1. Official Plan and Zoning By-law Amendment - 2 Montreal Road and 3 Selkirk Street

File Number: ACS2021-PIE-PS-0073

**SUBJECT: Official Plan and Zoning By-law Amendment - 2 Montreal Road and 3
Selkirk Street**

Document 8 – Conceptual Site Plan

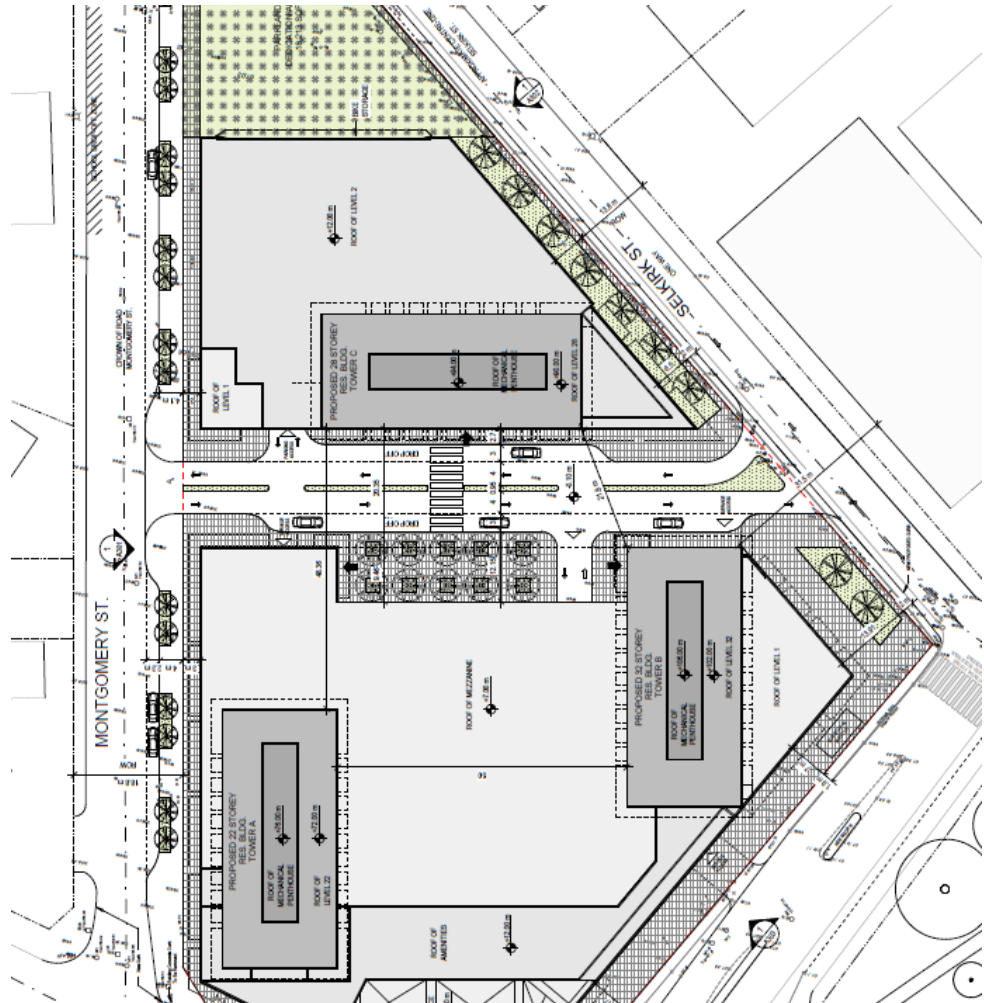
- The VCA believes that the preliminary concept plan is lacking in many respects, in terms of the MDSS Plan's policy directives for this site and its relationship with residents and visitors alike. The VCA is concerned the development not project a sense of "Gateway-gated community". The VCA welcomes efforts by the Applicant and the City to this end.
- The VCA also considers new public green spaces including City parkland and extensive landscaping is essential to create an environmentally-friendly "gateway" and a tree canopy connectivity with the Rideau shoreline and park.
- Protecting existing mature tree canopy and greenspaces is also important.
- The VCA is interested in exploring community benefits.

- Buildings placement: The VCA recognizes that in many respects the site is challenging. The river frontage apparently forces the Applicant to build above-ground parking which has changed the early concept plan and adds additional mass, particularly along Selkirk St. The VCA recognizes efforts to mitigate the risk of solid facades of the proposed "parkade" with art features. The flat roof lines could perhaps also be enhanced as per the recommendation of the Heritage report with the "barrel vaulting" of the existing shopping centre. Below we propose further setback from Selkirk especially to accommodate trees along Selkirk to improve walkability and mitigate the buildings impact along the street.

- Rezoning: The MDSS provides for a rezoning from 12 storeys to a maximum of 28 storeys which the VCA accepts on the basis that it represented a compromise. However, the Tower C proposal exceeds the MDSS height policy for this site and this would be expected to trigger the requirement for an Official Plan amendment. The VCA believes that 32 storeys is too high and suggests other means to distribute housing density on the site. Given the location along the Rideau and Riverain Park, which serve as a wildlife corridor, wildlife impacts along this corridor should be the subject of assessment. The total number of storeys could still be achieved by increasing the height of Tower B as part of the high-level visual gateway axis with Cummings Bridge to stay within the height limit for example or alternatively based on redesign of the Tower A podium.

- The VCA notes that the concept plan images still fail to reflect the reality of the west side of North River, ie berms and the narrow layout of south/west quadrant of intersection at Montreal Rd and North River which need to be considered in terms of pedestrian and cycling movements along the west side of North River. This could entail design changes to the parking lot at Riverain Park to increase accessibility from the development site. The limited landscaped setbacks of the concept plan affect the relationship to the park and MUP.

- The VCA is concerned that the current concept plan risks to look like a gated community rather than a gateway. As the concept plan evolves and there is a landscaping plan, we look forward to seeing more public spaces, both City parkland and POPS, not only at the corners of the site.
